SUBJECT: AMENDMENT NO. 203 TO FACILITY OPERATING LICENSE NO. DPR-49 - DUANE
 ARNOLD ENERGY CENTER (TAC NO. M85339)

DUANE ARNOLD ENERGY CENTER

Amendment No. 203
License No. DPR-49

ATTACHMENT TO LICENSE AMENDMENT NO. 203

DUANE ARNOLD ENERGY CENTER IES UTILITIES INC. TECHNICAL SPECIFICATIONS
DAEC OPERATING LIMITS FIGURE 3.6-1

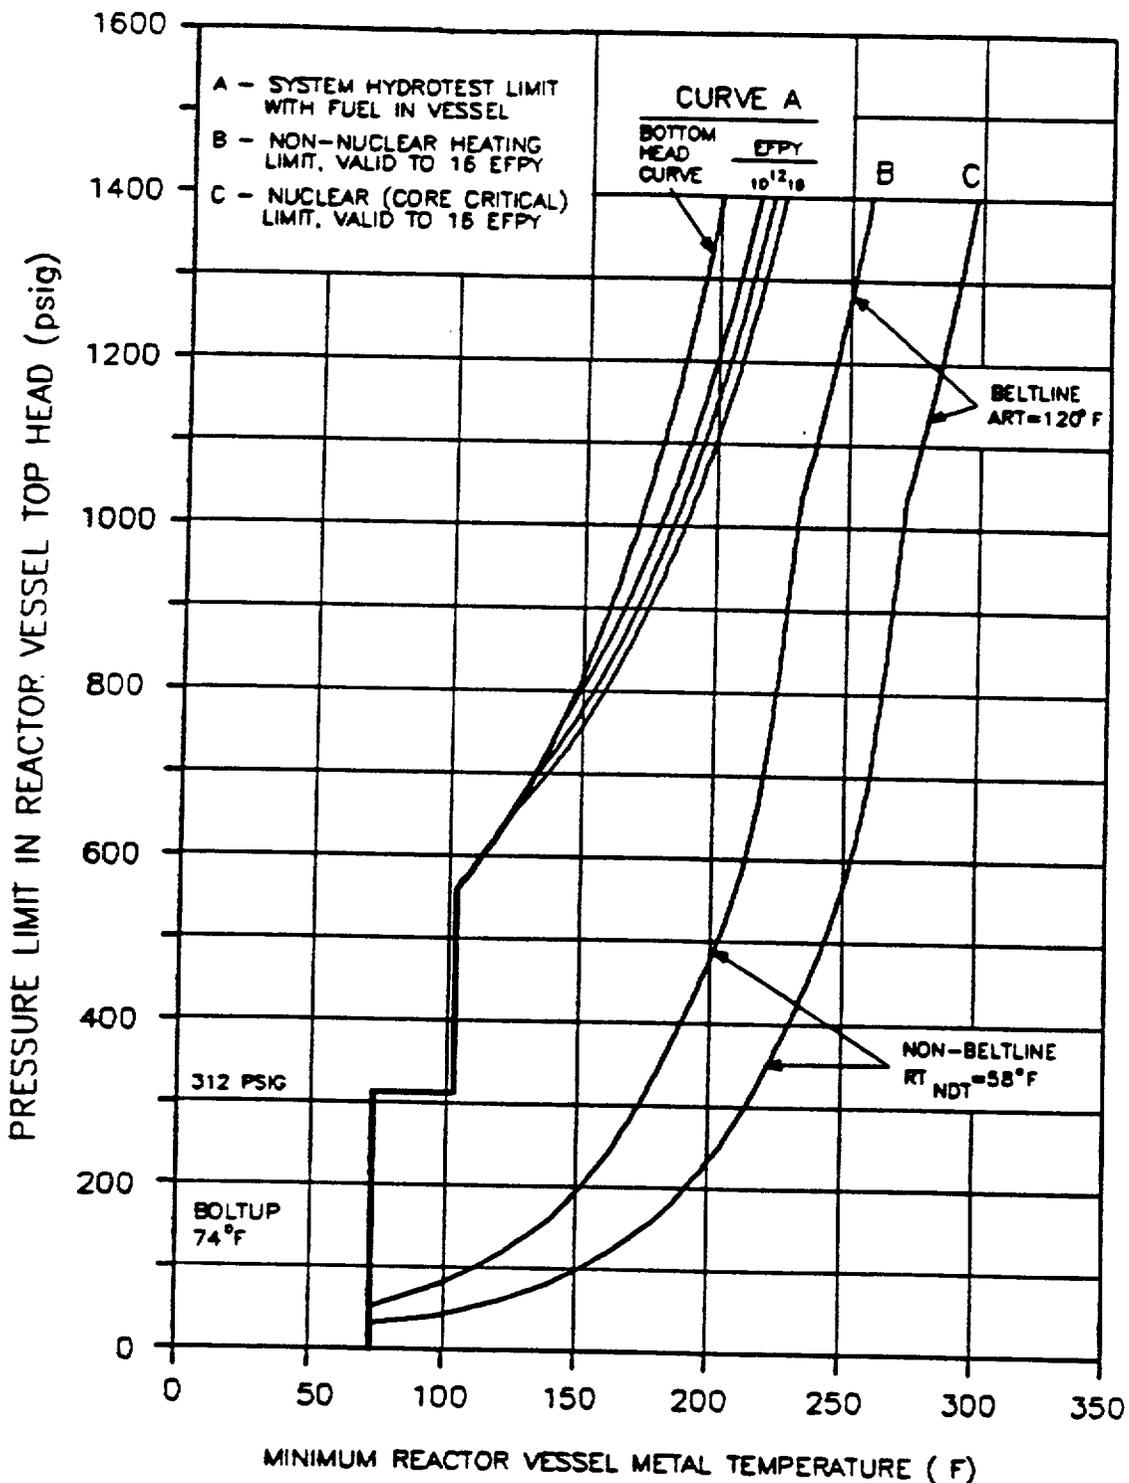
The licensee has proposed to revise TS Section 3.6.A.2 to delete from the LCO a commitment from the licensee to update TS Figure 3.6-1, Pressure versus Minimum Temperature Valid to Sixteen Full Power Years, per Appendix G of 10 CFR Part 50, prior to the expiration of 16 full power years, and to relocate the commitment to the Bases Section of the TS. This Figure gives the Pressure - Temperature Limit Curves for the DAEC reactor vessel. The staff approved Figure 3.6-1 on August 12, 1991. This commitment does not affect any surveillance requirements on the LCO, or provide any additional information to assist in the operation of the plant or in mitigating any accidents which could potentially occur. The staff has determined that this change is acceptable.

1. Average heatup/cool-down rate not to exceed 100 °F/hr
2. Reactor head required to be vented and no power operation allowed unless the reactor vessel temperature is greater or equal to Curve C in Figure 3.6-1
3. Reactor Vessel Studs shall not be placed in tension unless the temperature of the head flange and shell adjacent to the head flange are greater than 74 °F.

1. The average rate of reactor coolant temperature change during normal heatup and cooldown shall not exceed 100°F/hr when averaged over a one-hour period.
2. The reactor vessel shall be vented and power operation shall not be conducted unless the reactor vessel temperature is equal to or greater than that shown in Curve C of Figure 3.6-1. Operation for hydrostatic or leakage tests, during heatup or cooldown, and with the core critical shall be conducted only when vessel temperature is equal to or above that shown in the appropriate curve of Figure 3.6-1.
